ABBA TEMPLE SUBDIVISION

APPLICATION NUMBER 28 DATE January 3, 2008

REQUEST Subdivision

DETAIL SITE PLAN

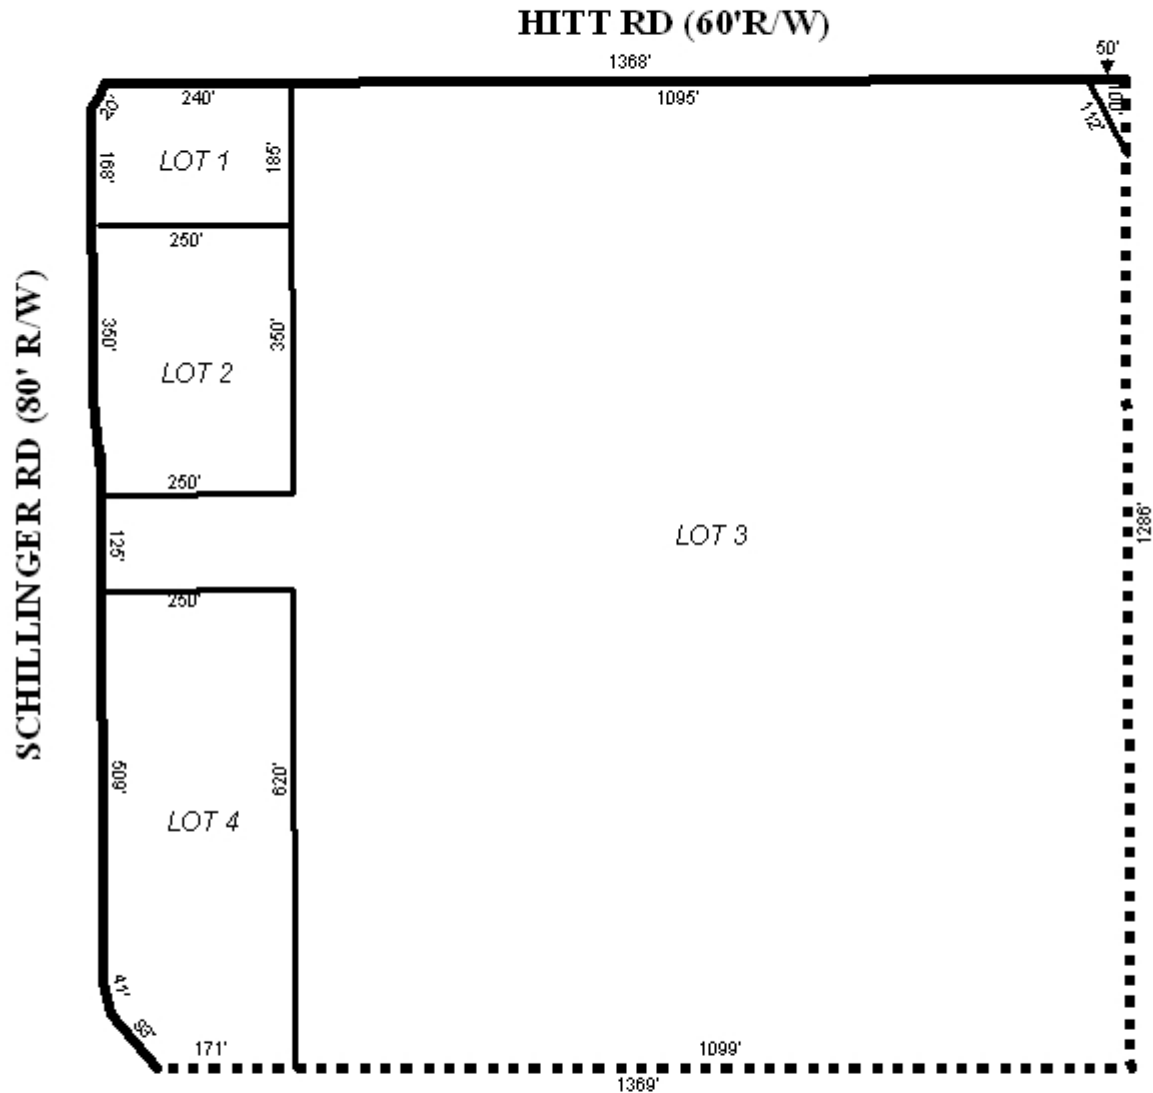
The site fronts Schillinger Road, a major street as illustrated on the Major Street Plan, which is illustrated on the preliminary plat as having 80-foot right-of-way; therefore, the dedication of right-of-way sufficient to provide 50-feet as measured from the centerline of Schillinger Road, should be required and Hitt Road, a minor street, which is illustrated on the preliminary plat with 60-foot right-of-way, is in compliance with the Subdivision Regulations.

The plat should be revised to dedicate sufficient radius at the intersection of Schillinger Road and Hitt Road, with the size and design to be approved by County Engineering and conform to AASHTO standards.

As illustrated on the preliminary plat the proposed subdivision would provide Lot 3 approximately 1098-feet± frontage on Hitt Road and approximately 125-feet± along Schillinger Road. Access management is a concern, as to the majority of the road frontage along Schillinger Road would provide access for Lots 1, 2 & 4. Therefore, Lot 1 should be limited to one curb cut to Hitt Road, to be located near the East property line and one curb cut to Schillinger Road located on the South property line and shared with Lot 2. Lot 2 should be limited to the shared curb cut with Lot 1 and one curb cut approximately 75-feet North of the South property line. Lot 3 should be limited to Hitt Road (existing) and one curb cut to Schillinger Road, located in the middle of the Schillinger frontage; and Lot 4 should be limited to two curb cuts to Schillinger Road, one located 75-feet South of the North property line and the other is the existing curb cut. All curb cuts to Hitt Road require Traffic Engineering approval and all curb cuts to Schillinger require County Engineering approval, with all curb cuts to conform to AASHTO standards.

The 25-foot minimum building setback line, required in Section V.D.9., is not shown for the entire subdivision, but would be required on the Final Plat, if approved.

- 1) dedication of sufficient right-of-way to provide 50-feet from the centerline of Schillinger Road;
- 2) the placement of a note on the Final Plat stating that Lot 1 is limited to one curb-cut to Hitt Road, to be located near the East property line and one curb cut to Schillinger Road located on the South property line and shared by Lot 2;

- 3) the placement of a note on the Final Plat stating that Lot 2 is limited to the shared curb cut with Lot 1 and one curb-cut approximately 75-feet North of the South property line;

- 4) the placement of a note on the Final Plat stating that Lot 3 is limited to one curb cut to Hitt Road (existing) and one curb cut to Schillinger Road, located in the middle of the Schillinger Road frontage;

- 5) the placement of a note on the Final Plat stating that Lot 4 is limited to two curb-cuts to Schillinger Road, one located approximately 75-feet South of the North property line and the other is the existing curb cut;

- 6) the placement of a note on the Final Plat stating that all curb cuts to Hitt Road require Traffic Engineering approval and conform to AASHTO standards and all curb cuts to Schillinger Road require County Engineering approval and conform to AASHTO standards;

- 9) revision of the plat to label the lot with its size in square feet, or placement of a table on the plat with the same information;
- 10) the placement of a note on the final plat stating that any lots which are developed commercially and adjoin residentially developed property must provide a buffer, in compliance with Section V.A.7 of the Subdivision Regulations; and
- 11) the depiction of the 25-foot minimum building setback line on the entire subdivision on the Final Plat.
